FOIA/PA NO:   2013-0240

**From:** Wagner, Katie  
**Sent:** Tuesday, May 15, 2012 7:56 PM  
**To:** Barto, Andrew; Sullivan, Randy; Schrader, Eric; Jones, Steve; Mitman, Jeffrey; Bowman, Eric; Witt, Kevin; Tegeler, Bret; Powell, Eric  
**Cc:** Gibson, Kathy; Scott, Michael; Poole, Brooke; Lewis, Robert; Ruland, William; Glitter, Joseph; McGinty, Tim; Ader, Charles; Bergman, Thomas; Skeen, David; Evans, Michele; Clifford, James; Lee, Richard; Coyne, Kevin; Hogan, Rosemary; Santiago, Patricia; Wood, Kent; Hansell, Samuel; Ennis, Rick; Esmaili, Hossein; Helton, Donald; Murphy, Andrew; Nosek, Andrew; Pires, Jose  
**Subject:** RE: ACTION: Spent Fuel Pool Scoping Study (SFPSS) Working Draft for Working Group Review by EOB on Tue., May 22nd

Attached is a working draft for review and comment by Other-Office Working Group members by end-of-business on Tuesday, May 22<sup>nd</sup>. We understand that this is a large document and the review time is relatively short, we appreciate your input to help meet our deadlines. A few notes about this document:

X-Y View of Unit Cell at Axial Mid-Plane for the BWR rack.

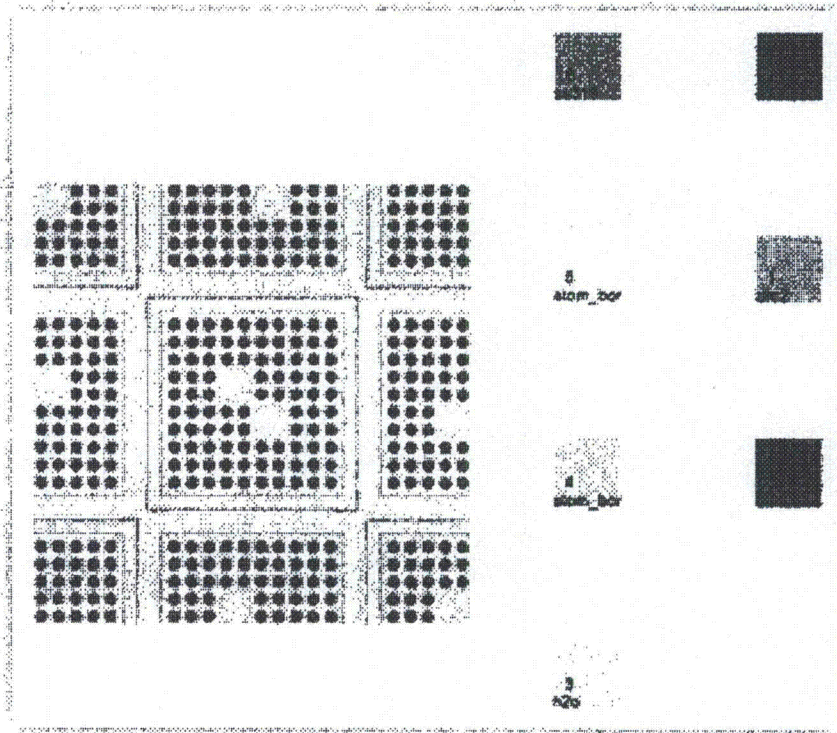
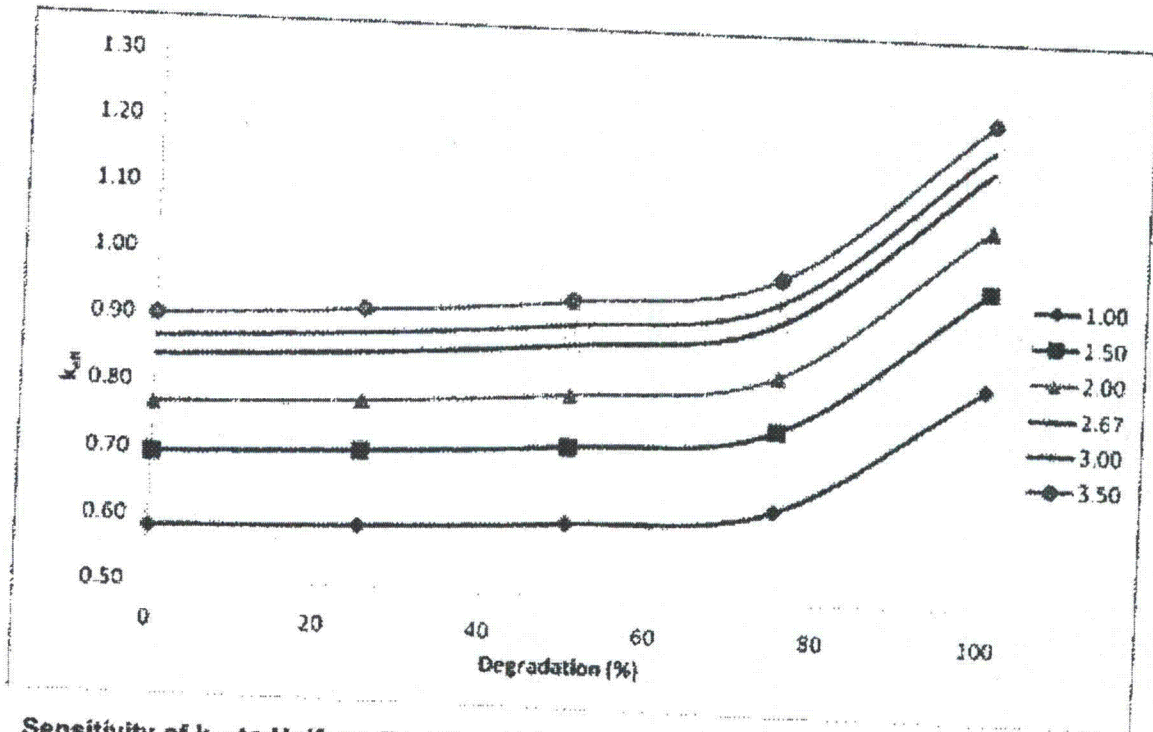
The purple curve would likely be of most interest since this corresponds to the reactivity equivalent of spent fuel at peak reactivity. Of course, this is for full density water. If you still want, I can do a criticality search iterating over moderator density at 100% absorber degradation to find the optimum moderation. Let me know.

I'm not sure how helpful this particular case is considering we don't know their pool design and management scheme.
